Bitters Pump Station Upgrades and Tank Replacement
Solicitation Number: CO-00601-SM
Job No.: 20-6007

ADDENDUM No.3
June 30, 2023

A AREA LIGHT POLE (TYPICAL)
SCALE: N.T.S.

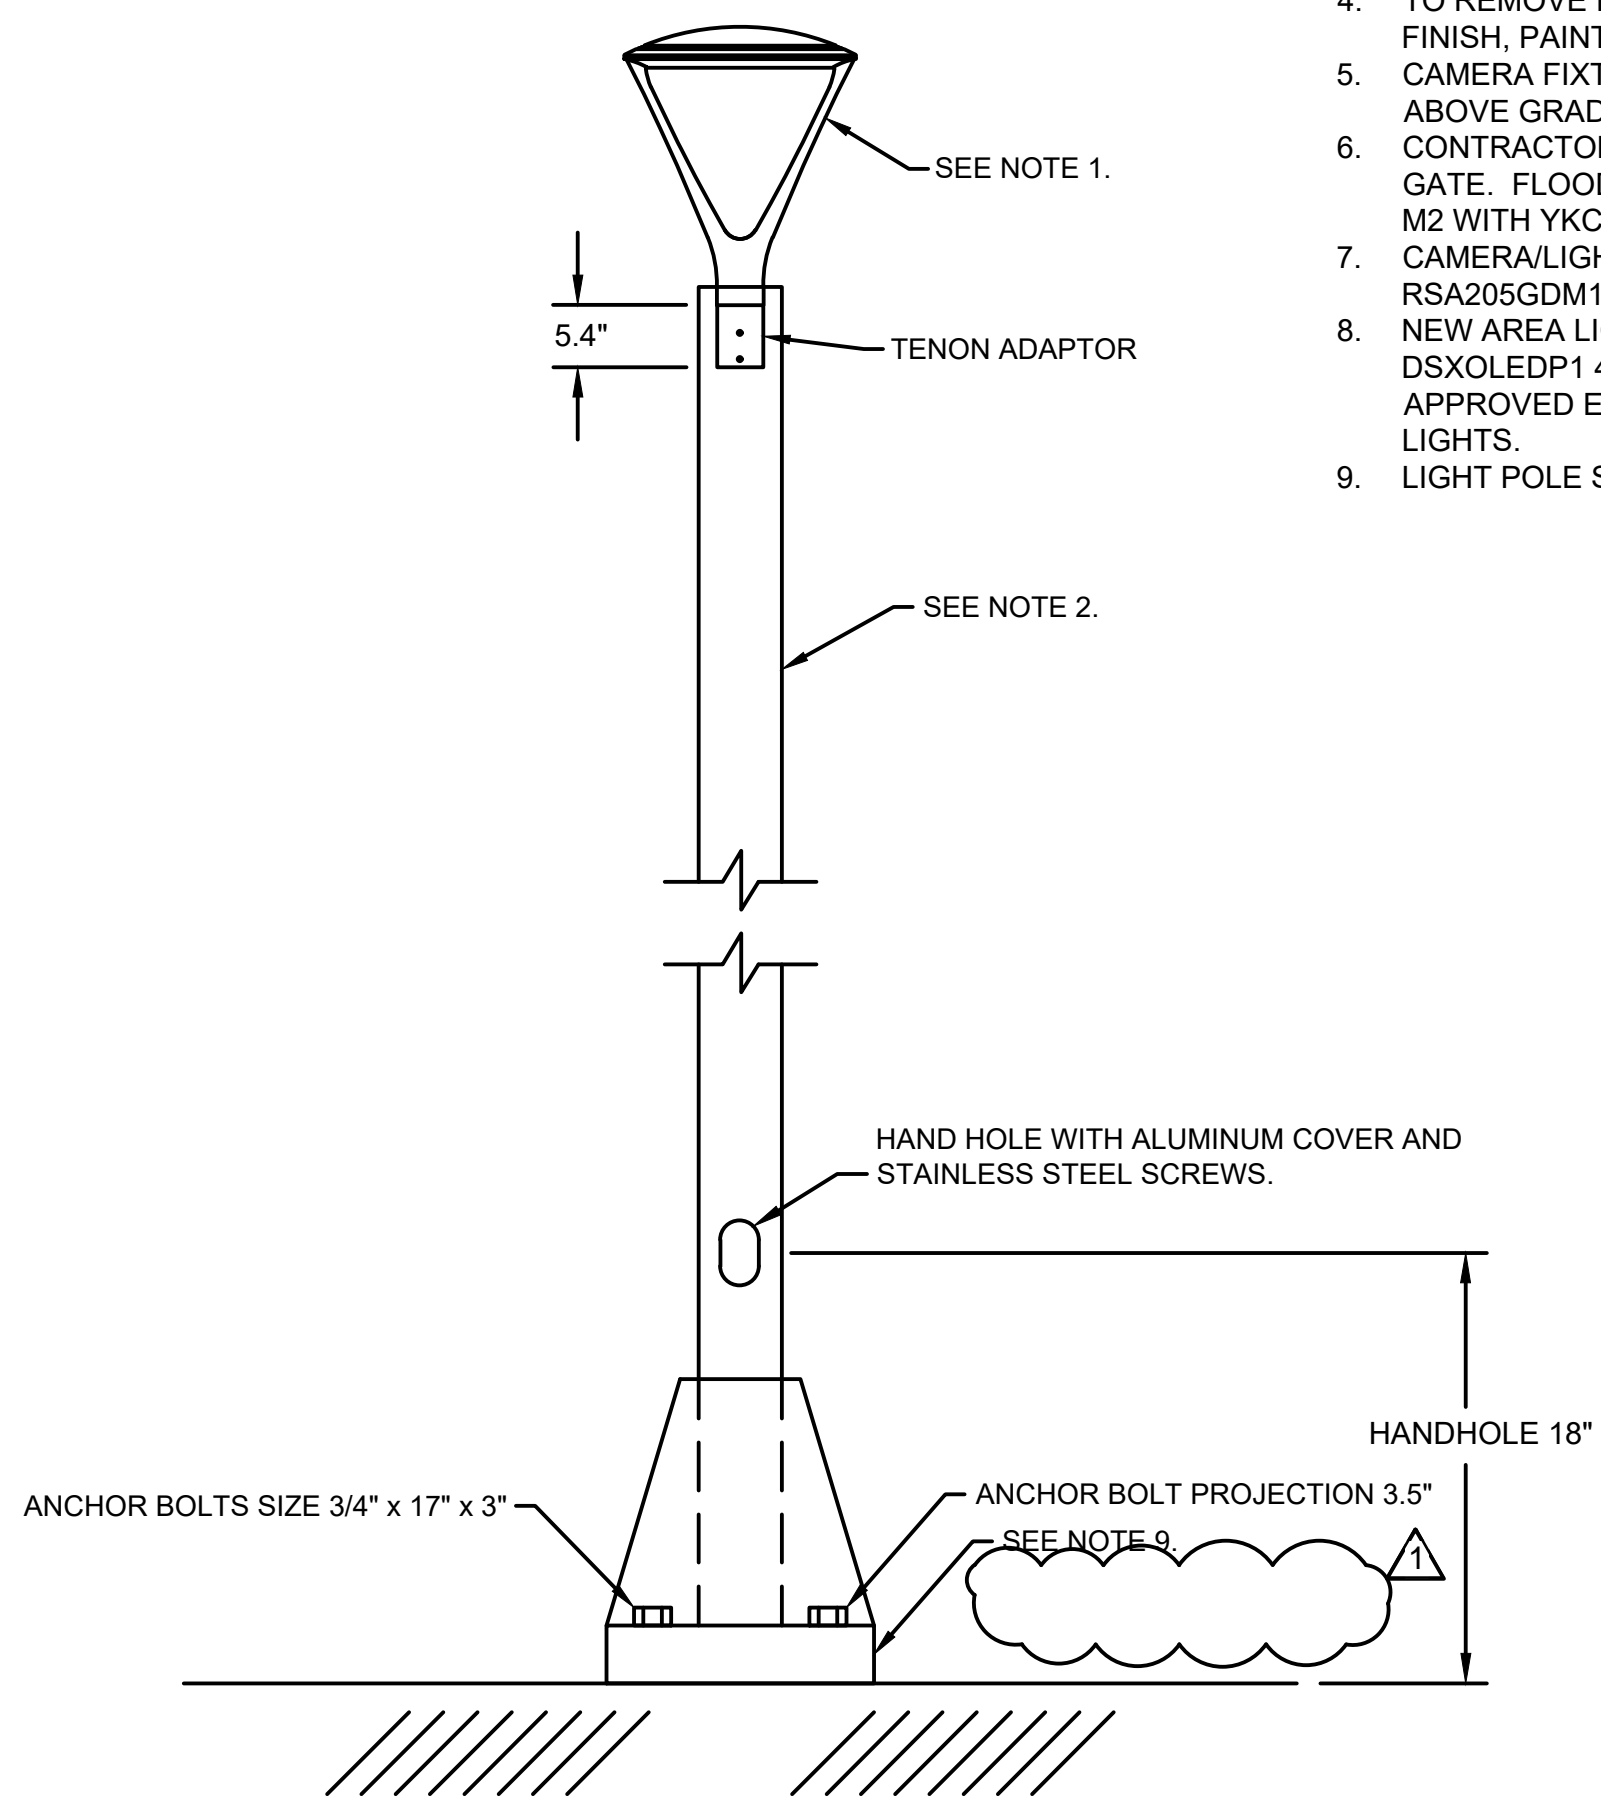
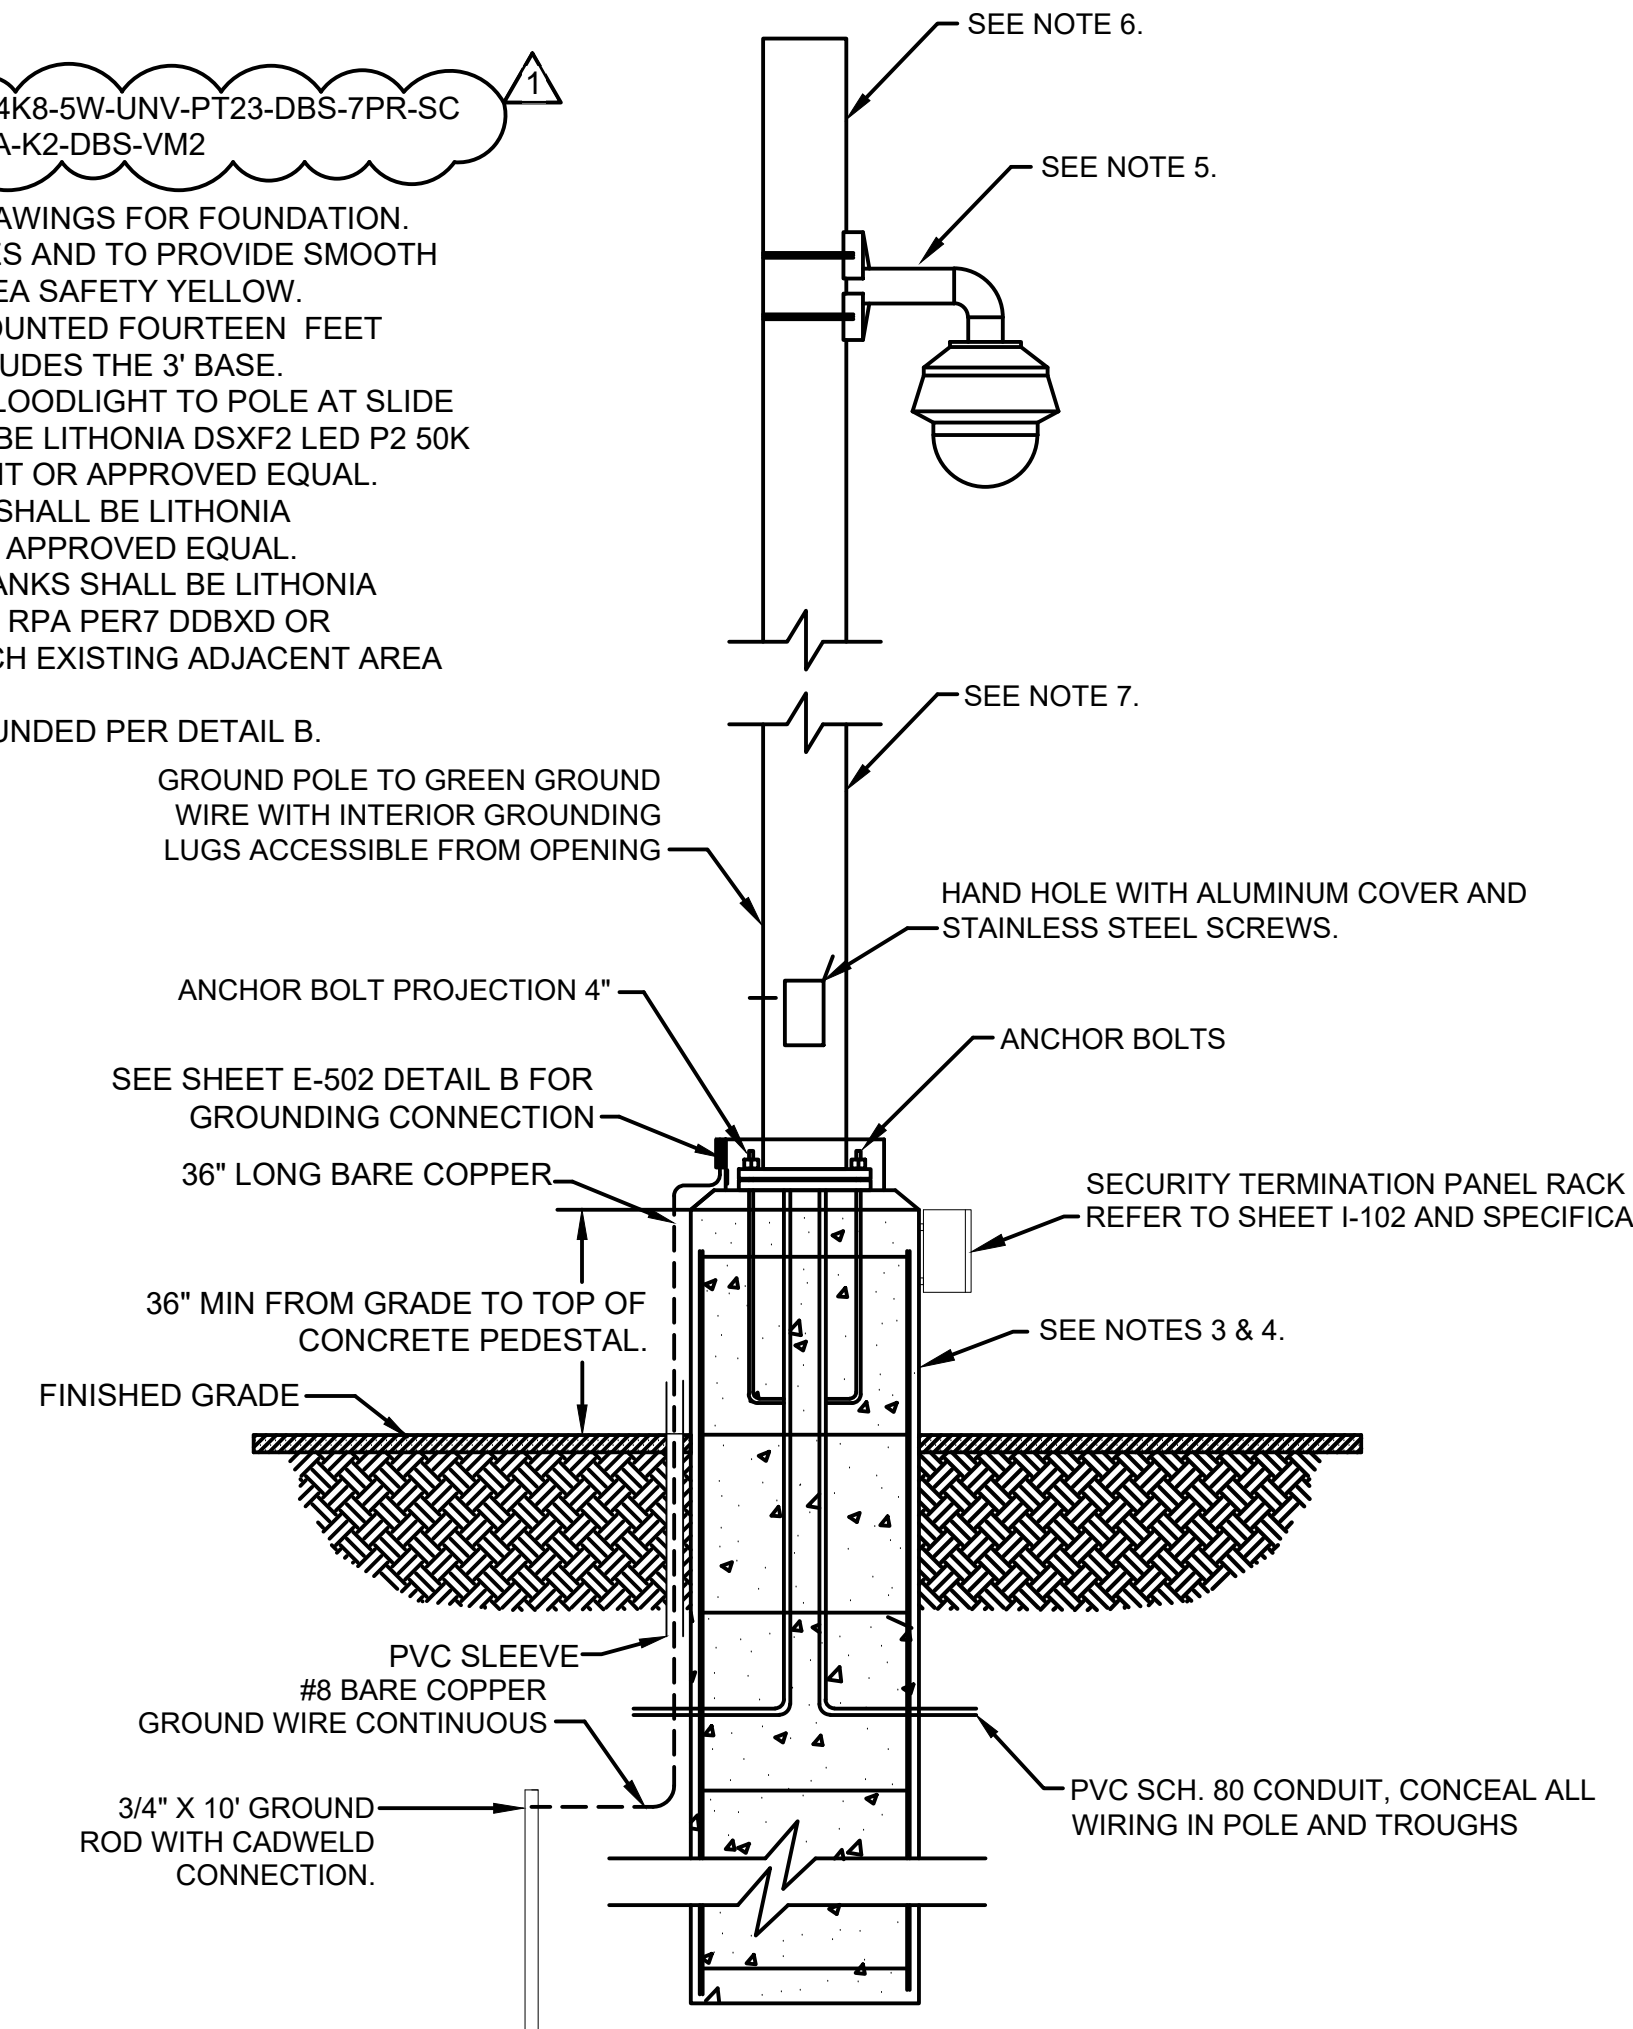
- 1. Question: Sheet E-106 Note 16 calls out a Hubbell fixture to be used to replace the existing demolished pole lights. Sheet E-114 Detail A calls out a different fixture and pole. Which part number is to be used for the area pole light replacements?**

Response: The model numbers for the light pole and fixture are Hubbell RTS-K-20-60-A-TA-K2-DBS-VM2 and Hubbell UR20-28L-70-4K8-5W-UNV-PT23-DBS-7PR-SC, respectively. See “Changes to the Plans” Sheet E-114.
- 2. Question: Please provide Word Version of the Evaluation Criteria fillable forms.**

- GENERAL NOTES:**
1. FIXTURE CAT# UR20-28L-70-4K8-5W-UNV-PT23-DBS-7PR-SC
POLE CAT# RTS-K-20-60-A-TA-K2-DBS-VM2
 2. SEE STRUCTURAL PLAN DRAWINGS FOR FOUNDATION.
TO REMOVE IRREGULARITIES AND TO PROVIDE SMOOTH
FINISH, PAINT EXPOSED AREA SAFETY YELLOW.
 3. CAMERA FIXTURE TO BE MOUNTED FOURTEEN FEET
ABOVE GRADE, WHICH INCLUDES THE 3' BASE.
 4. CONTRACTOR TO MOUNT FLOODLIGHT TO POLE AT SLIDE
GATE. FLOODLIGHT SHALL BE LITHONIA DSXF2 LED P2 50K
M2 WITH YKC62 YOKE MOUNT OR APPROVED EQUAL.
 5. CAMERA/LIGHT POLE BASE SHALL BE LITHONIA
RSA205GDM19VDDDBXD OR APPROVED EQUAL.
 6. NEW AREA LIGHT BEHIND TANKS SHALL BE LITHONIA
DSXOLEDP1 40K T2S MVOLT RPA PER7 DDBXD OR
APPROVED EQUAL TO MATCH EXISTING ADJACENT AREA
LIGHTS.
 7. LIGHT POLE SHALL BE GROUNDED PER DETAIL B.
